Service Advisory

W-126

Models Affected: LT-1500 (13A2606G190); LT1650 (13A4616G190); LT1850 (13A6616H190); GT2150 (14A6816H190); GT-2550 (14A9816K190)

Subject: P/N 725-1426 STARTER SOLENOIDS

FIGURE 1

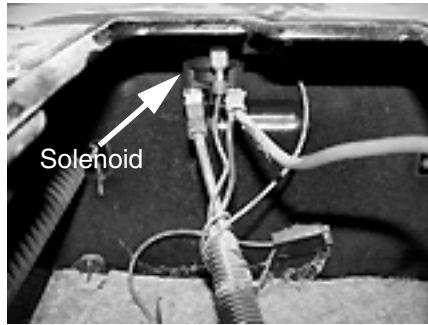
1. Turn key to the OFF position and remove from ignition switch.
2. Place parking brake in the ON position.
3. Locate the battery and disconnect the NEGATIVE (Black) wire first, followed by the POSITIVE (Red) wire next.
4. Refer to Figure 1 on Page 2. The solenoid is located under the rear fender mounted to the hitch plate, see Figure 1. Remove the battery and battery tray to gain access to the solenoid.

FIGURE 2

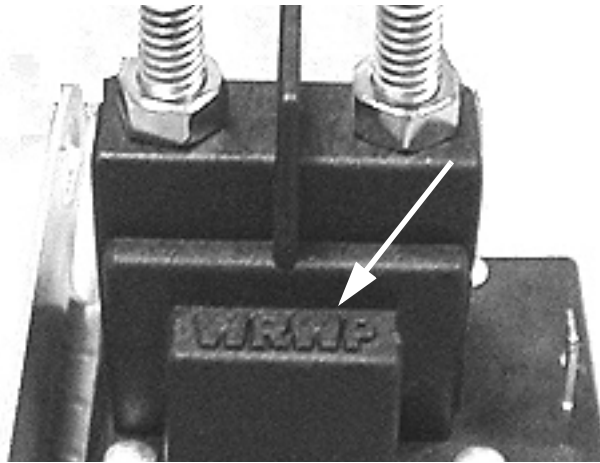
5. Locate the solenoid for unit being repaired.
6. Observe and record the connection location of the following wires to the solenoid. The POSITIVE (Red) and NEGATIVE (Black) wires coming from the battery, the heavy red wire from the harness, the green wire from the harness and the orange/white wire to the solenoid's flat blade terminal for reconnection in a later step. Dependent of tractor model the NEGATIVE (Black) battery wire may be connected at the frame and not the solenoid.
7. Depending on the solenoid location either remove the solenoid from the frame first then disconnect the wires from the solenoid or disconnect the wires from the solenoid and then remove the solenoid from the frame.
8. Retain the old solenoid for warranty.

9. Reversing the removal instructions above, install a supplied replacement solenoid (P/N 725-1426). Make sure the green wire from the harness is against the metal bracket of the solenoid. Tighten mounting bolts.
10. Reconnect the remaining wires removed in Step 7 above in accordance with the locations recorded in Step 6.
11. Torque the 1/4"-20 nuts on the two 1/4"-20 copper studs to 20-28 inch-pounds.
12. Double check the installation against that was recorded in Step 6.
13. Replace the battery tray and battery if removed in Step 4.
14. Connect the POSITIVE (Red) wire to the battery first. Then connect the NEGATIVE (Black) wire to the battery.
15. Test the installation by performing the START TEST as outlined in the START TEST section above.
16. This concludes the solenoid test and replacement.
